NPP BUGEY 3 LTO ENVIRONMENTAL IMPACT ASSESSMENT

Expert Statement

Oda Becker
Kurt Decker
Nikolaus Muellner
Bojan Tomic

Contracting authority Federal Ministry of Agriculture and Forestry, Climate and Environmental Protection, Regions and Water Management; Directorate General VI - Environment and Climate; Directorate VI/8 General Coordination of Nuclear Affairs

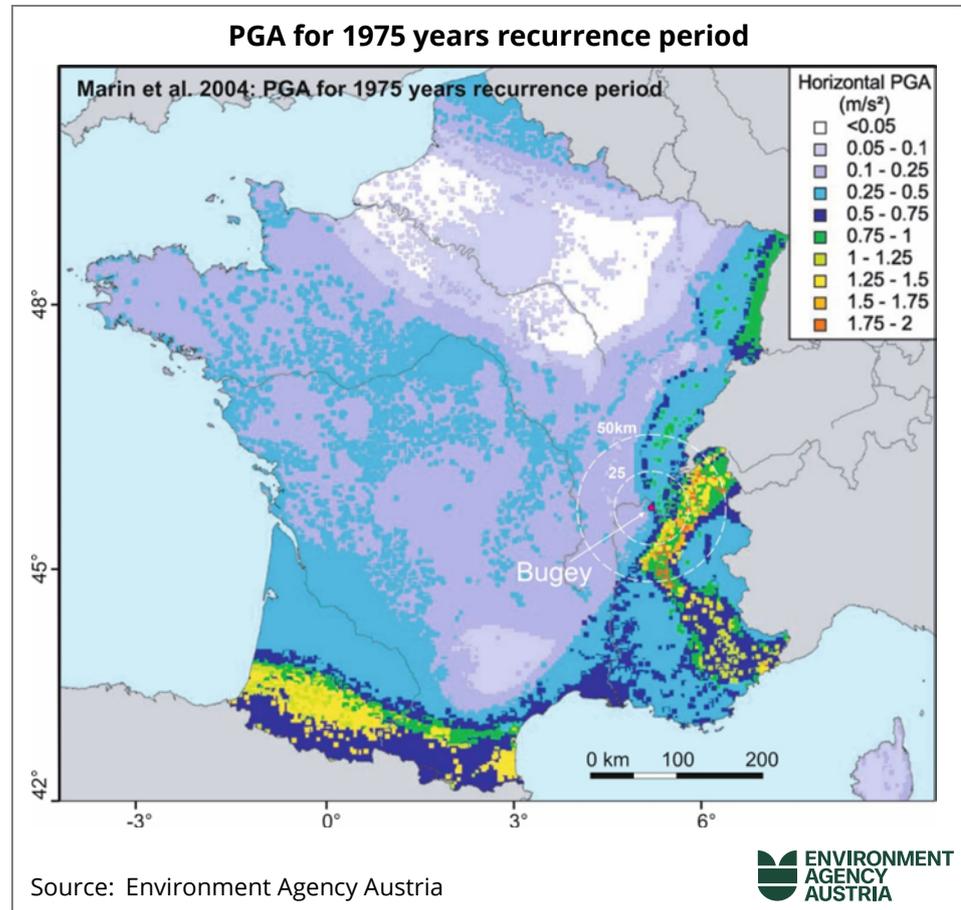
The EIA documents provide some information on the derivation and re-assessment of the deterministically design basis earthquake SMS. A re-assessment in the course of the 4th PSR led to higher ground motion values (spectral accelerations). EDF, however, claims that these higher hazard values have no influence on seismic safety (EIA-REPORT D.2 2026, p. 133). The EIA documents provide no information on the content, methodology and results of the seismic hazard re-assessment. It remains open how EDF ensured that the seismic resistance of SSCs important to safety is in line with the requirements of the newly defined higher design basis ground accelerations. Such demonstration requires the assessments of seismic fragilities of SSCs important to safety, the determination of seismic margins etc. It is also unclear if the deterministically determined SMS ground motion values have been compared to the results of probabilistic hazard analyses as required by WENRA (2021), Issue TU.

0.3 and 0.4 g, respectively (Table 2). These values appear low compared to the ground motion derived from the published probabilistic seismic hazard assessment (PSHA) by MARIN et al. (2004) who shows a PGA value of at least 0.25 g for the site and a recurrence interval of 1975 years (Figure 1)¹³. This value (0.25 g) is significantly higher than the ground motion reported for the SMS (0.145 g) indicating that the deterministically derived SMS fails to meet WENRA (2021) requirements stipulating that “an exceedance frequency not higher than 10^{-4} per annum shall be used for the design basis events”¹⁴.

Figure 4: Cooling devices in the event of core melt accident (EIA-REPORT D.1 2026)

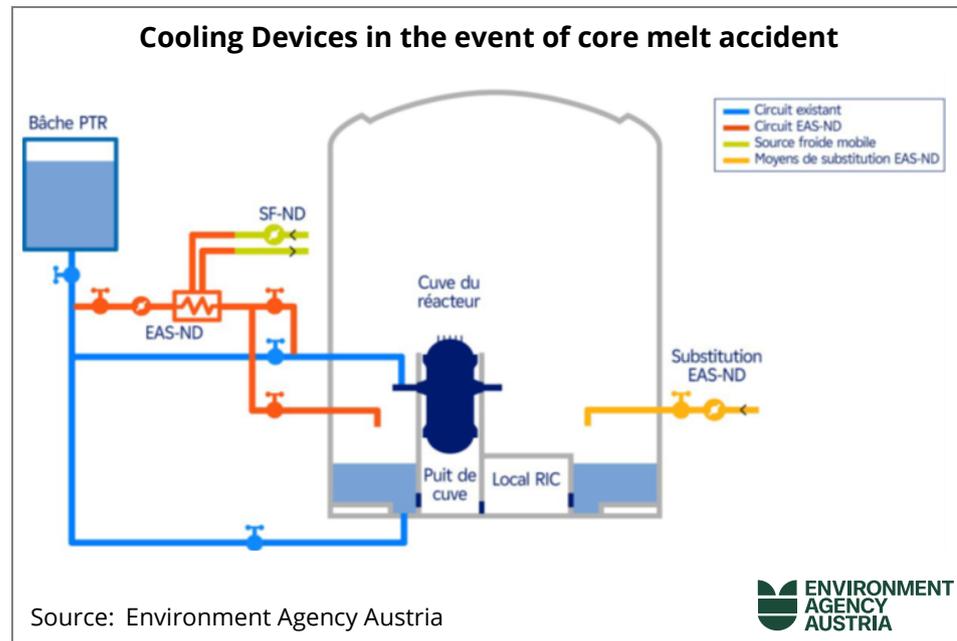
Based on current knowledge, a failure of the containment cannot be ruled out after the modification to stabilize and cool the molten core has

been implemented. On the one hand, not all important modifications have been implemented yet, and on the other hand, it is not possible to assess whether the modifications (especially the reinforcement of the basement) are sufficient based on the available information.
